## ARCHITECTURAL REVIEW BOARD MUNICIPAL PLANNING COMMISSION -AGENDA-

Thursday, December 14, 2023 at 7:00 P.M.

#### **MEMORANDUM**

DATE: December 8, 2023

New Heat Pump Plan

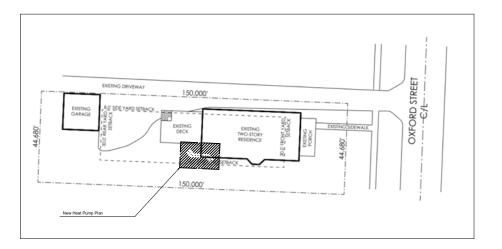
- such system is located shall be installed and maintained with such exterior unit located to the rear of the dwelling unit.
- (b) The provisions of subsection (a) hereof notwithstanding, building service equipment may be located at the side of the dwelling, provided that the equipment shall be effectively screened on the front and sides by an evergreen hedge or dense planting of evergreen shrubs not less than the height of the equipment, or by a fence or wall of similar height conforming to Chapter 1180.

THAT THE REQUEST BY MICHAEL SIROSKEY FOR A CERTIFICATE OF APPROPRIATENESS TO ADD A HEAT PUMP AT 569 OXFORD ST., AS PER CASE NO. ARB 96-2023, DRAWINGS NO. ARB 96-2023, DATED NOVEMBER 17. 2023, BE APPROVED BASED ON THE FINDINGS OF FACT AND CONCLUSIONS IN THE STAFF MEMO AND PRESENTED AT THE MEETING.

CITY OF WORTHINGTON DRAWING NO. ARB 97-2023 DATE 11/18/2023

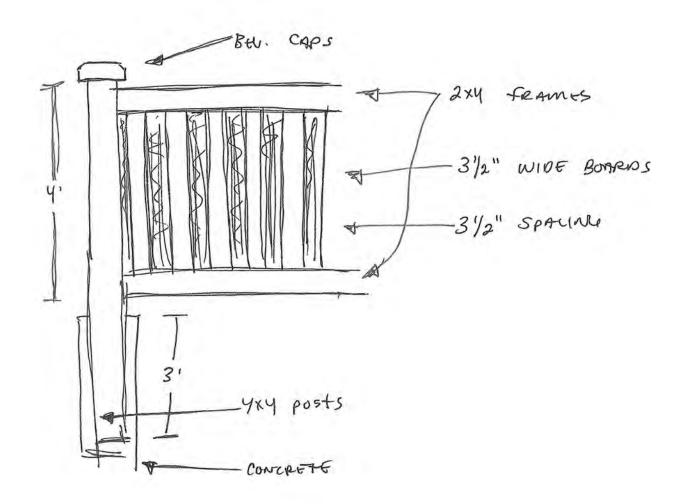
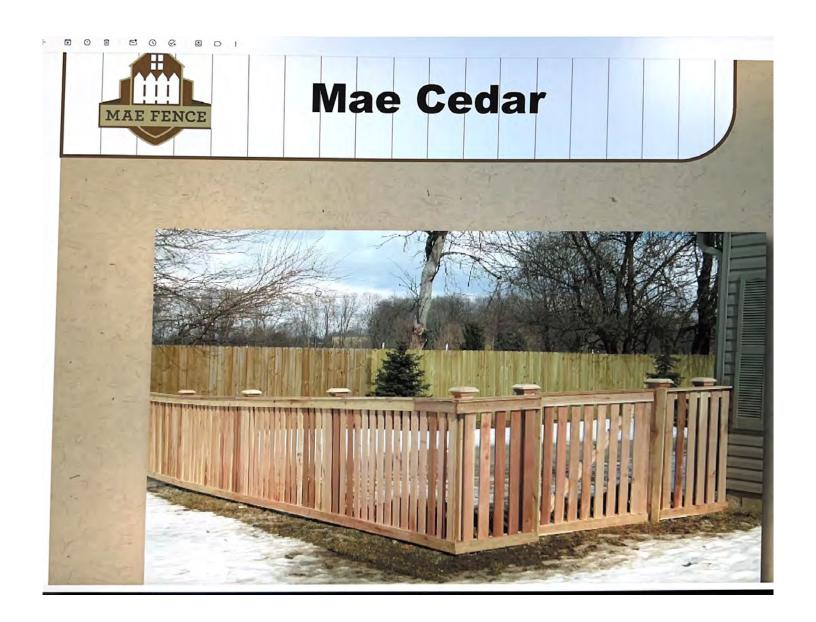
- 1. The existing fence is green wire farm fencing mounted on 4" x 4" wood poles that surrounds the rear yard behind the garage and driveway.
- 2. Proposed is a 4' high cedar picket fence with rails at the top and bottom. The fence would have  $3\frac{1}{2}$ " wide pickets spaced  $3\frac{1}{2}$ " apart.
- 3. Fences must be at least 30' from any right-of-way in the R-10 Zoning Districts. As there is an alley adjacent to the rear of the property, a variance would be needed to replace the fencing in its current location.

THAT THE REQUEST BY AMY WEINSZ FOR A CERTIFICATE OF APPROPRIATENESS TO REPLACE FENCING AT 148 E. SOUTH ST., AS PER CASE NO. ARB 97-2023, DRAWINGS NO. ARB 97-2023, DATED NOVEMBER 18, 2023, BE APPROVED BASED ON THE FINDINGS OF FACT AND CONCLUSIONS IN THE STAFF MEMO AND PRESENTED AT THE MEETING.

## SITE PLAN - NATATORIUM

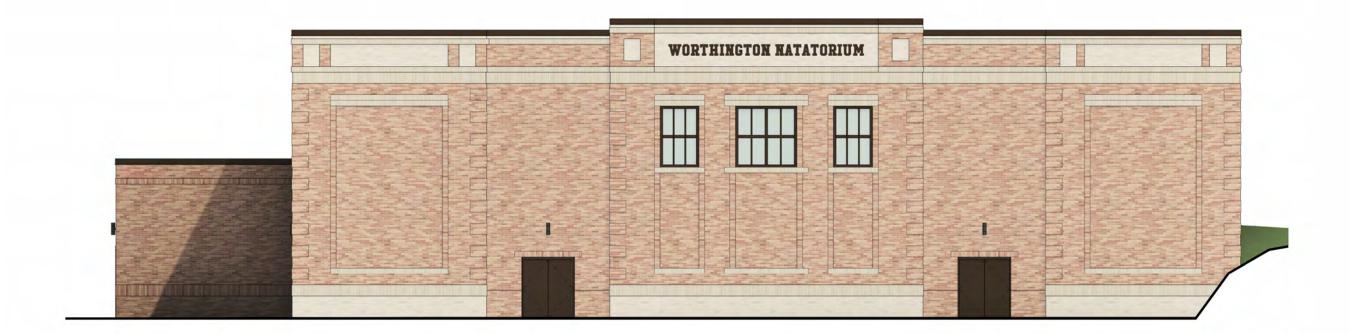
- b. A parking area is proposed north of the new building and would include 28 regular parking spaces plus 2 handicap spaces. Two entrance drives would provide access from the main driveway that leads to the high school parking lot. A sidewalk is proposed winding down to and along the east and south sides of the parking lot, across the drive, and along the west side of the building. More detail of the walkways is needed.

- c. Preservation of 7-8 trees that are in good condition is proposed. Twenty trees would be removed due to location and/or condition. A variety of new trees are proposed in the parking area and at other locations around the site. Sod would be on the slope down from the outdoor pool level to the new parking lot. A new landscape plan is needed.

SITE PLAN

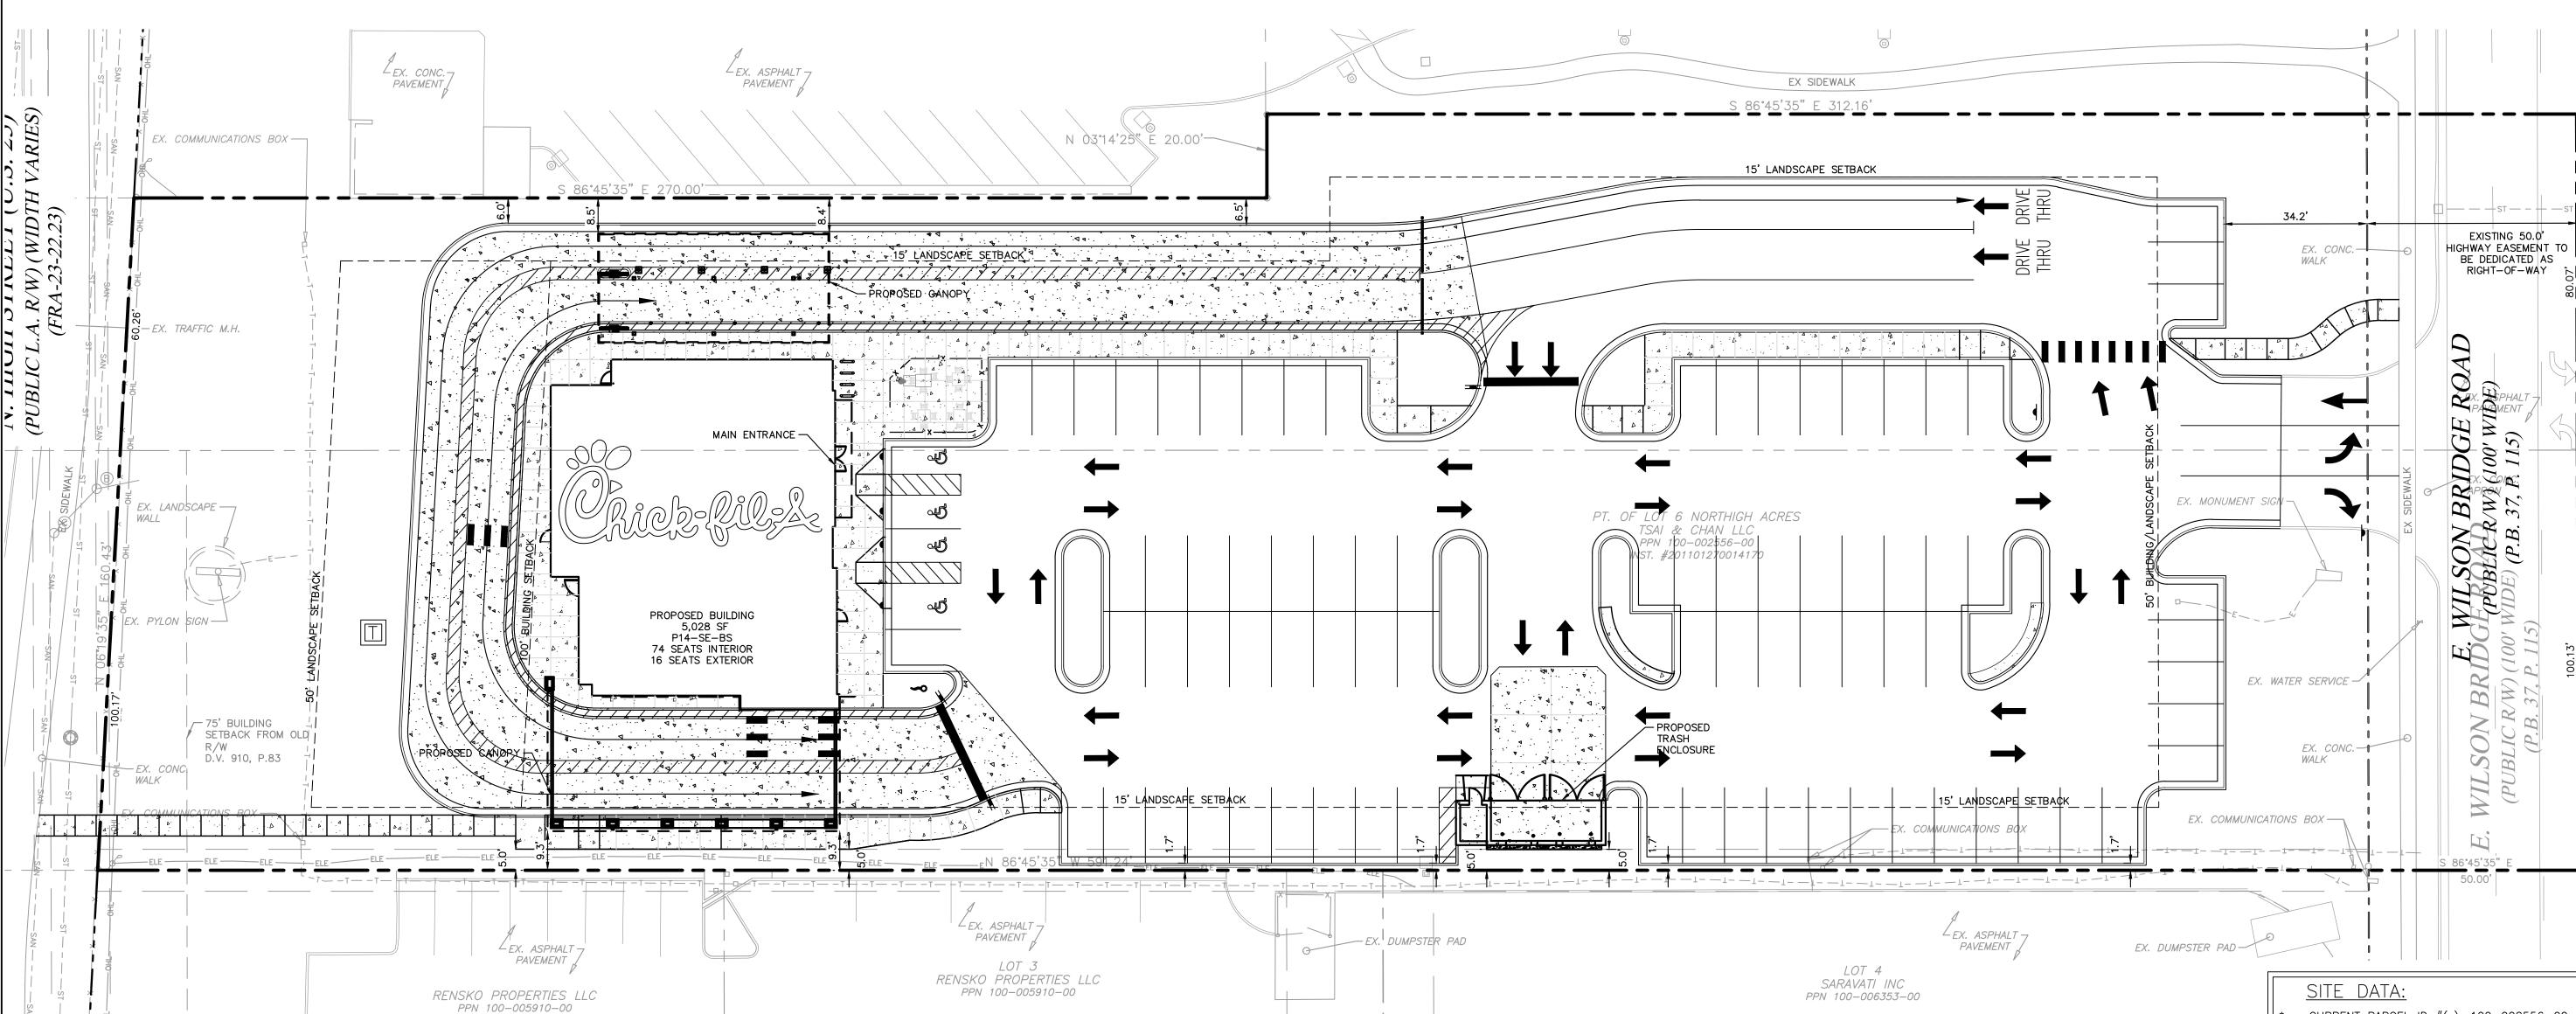
- At about 155' east of the building, the pavement would change to concrete. The two drive-thru lanes would continue around the building, coming as close as 70' to the N. High St. right-of-way vs. the previously proposed 50', and transition back to asphalt just east of the building. The parking on the south side is proposed at the property line.

- e. Magnetic delineators that were previously proposed all along the lanes are no longer shown on the civil plan, but delineators and team member crossing signs are shown on the architectural plans.

- The revised plans show a sidewalk along the southern portion of the site extending out to N. High St.
    - This portion of N. High St. is limited in access and sidewalks directly to the N. High St. public right-of-way is likely not permitted.

- o Catalogue cuts or photographs are needed.
  - The area is proposed as concrete and surrounded by a black metal picket fence.
- h. Bicycle Racks:
  - Four inverted "U" bicycle racks are proposed in front of the building at the north end. Modifications have been made to the location of the bike racks.

SITE PLAN

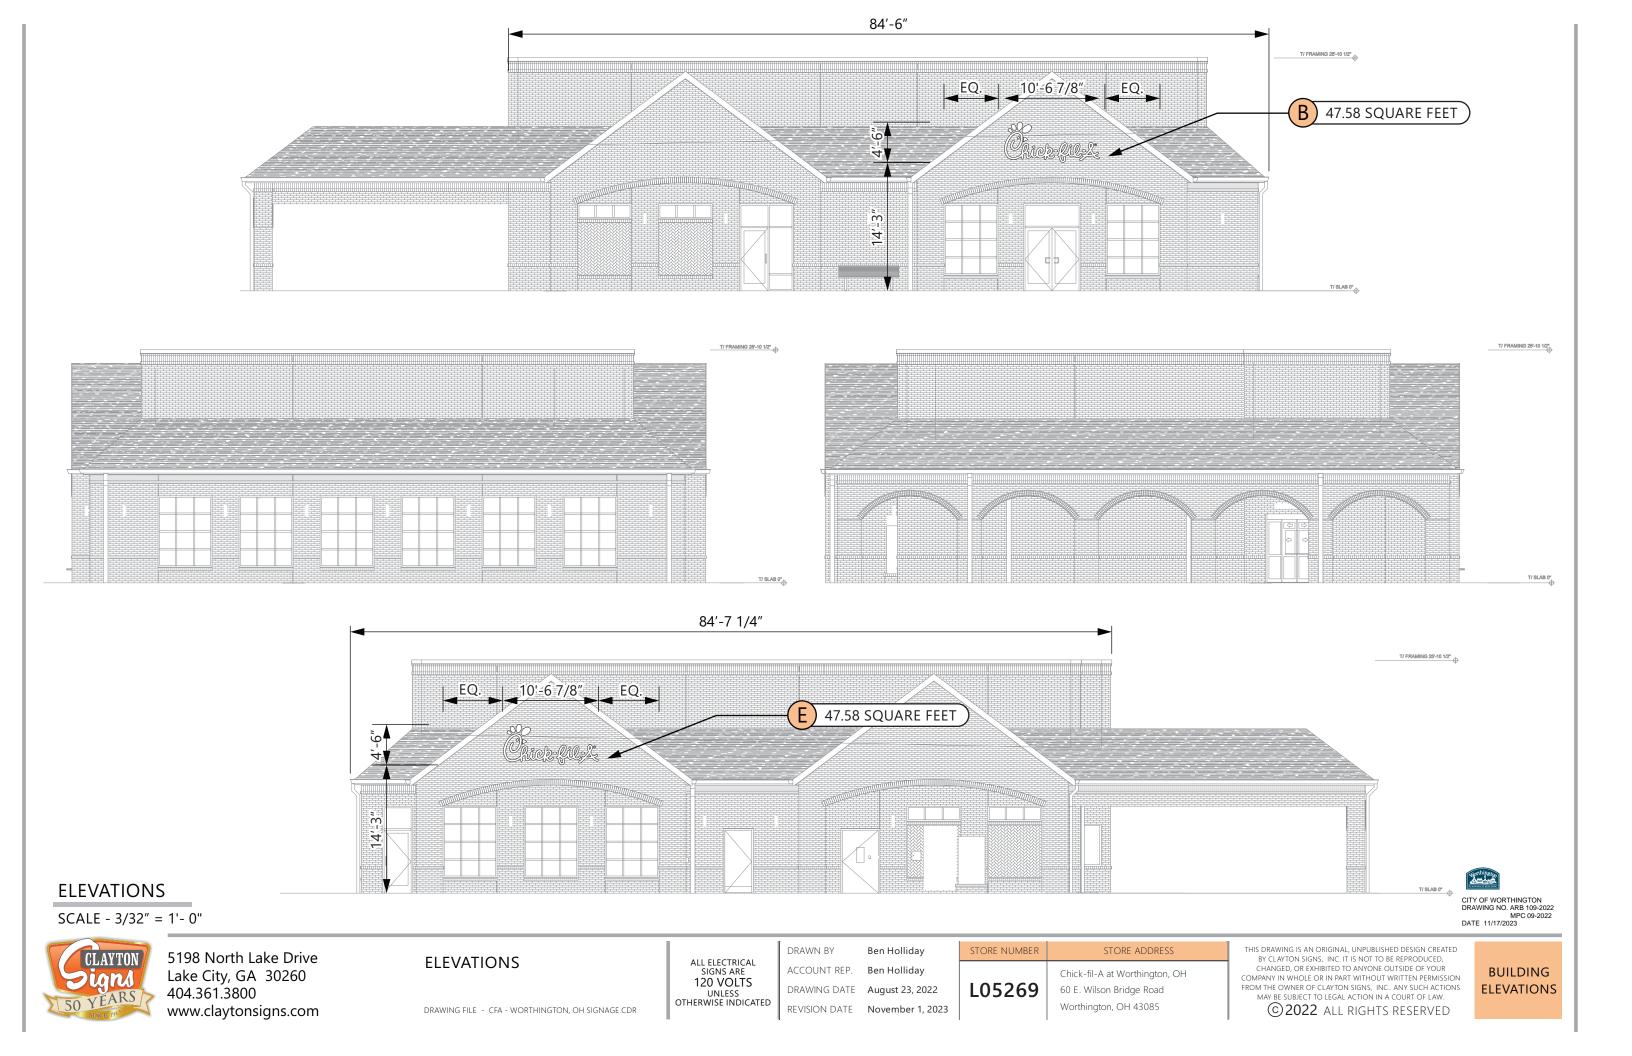
- Regulatory signs such as stop, do not enter, and handicap parking are shown as part of the sign package but approval is not necessary.
- One 2' high x 2' wide "Drive Thru/Dine In" sign with arrows is proposed near the site entrance. Total height would be 3'.
- Other directional signs are shown on the site plan under the canopies, but the style, size and number have not been identified.
- Curbside pickup signs have not been included with this submittal but are expected at a later date.

- Directional sign area cannot exceed 20 square feet for the site, and the signs must meet dimensional requirement. It seems the proposed will exceed those requirements, but further information of signs indicated on the site plan as well as any curbside pickup signs is needed. Magnetic and moveable delineators would also be considered directional signs.

- c. Graphics proposed for the glass doors must be on the inside of the glass.
  - d. The amount of proposed signage for the site has been lessened.
  - e. A thoughtful, minimal plan for other directional signs will be expect when the operator has been chosen.

#### **Revised elevation**

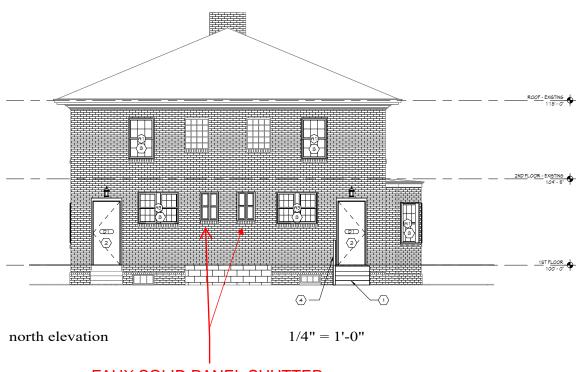
This is a request to remove two rear windows and install shutters in their place.

- 1. The windows in question are small windows in the middle of the first floor.
- 2. Two shutters would be installed over each window opening and each shutter would have two vertical panels.
- 3. The shutters are proposed to be white.
